UNITED STATES PATENT AND TRADEMARK OFFICE

APPLICATION NO.	FILING DATE	FIRST NAMED INVENTOR	ATTORNEY DOCKET NO.	CONFIRMATION NO.
10/708,881	03/30/2004	Darrel Brodke	101896-0244	2880
21125 7590 08/23/2007 NUTTER MCCLENNEN & FISH LLP WORLD TRADE CENTER WEST 155 SEAPORT BOULEVARD BOSTON, MA 02210-2604			EXAMINER RAMANA, ANURADHA	
			ART UNIT 3733	PAPER NUMBER
			MAIL DATE 08/23/2007	DELIVERY MODE PAPER

Office Action Summary

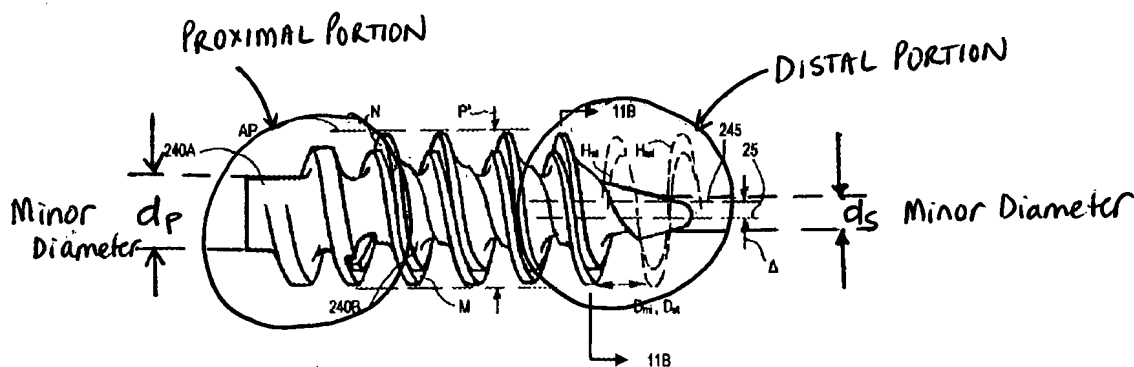
Shadduck discloses a shank having a proximal portion with a constant minor diameter; a distal portion with a minor diameter that decreases in a proximal-to-distal direction; and opposed first and second helical threads that extend around at least a

portion of the proximal and distal portions of the shank; wherein the thread depth remains constant along the length of the shank. See marked up Fig. 7 from Shadduck below.

As illustrated above, at least partial revolutions of the helical threads extend around at least a portion of the proximal and distal portions.

Regarding claim 30, Applicants' arguments are not directed to claim limitations. As illustrated above, the shank of the Shadduck bone screw has a proximal portion with a constant minor diameter and a distal portion with a minor diameter that decreases in a proximal-to-distal direction.
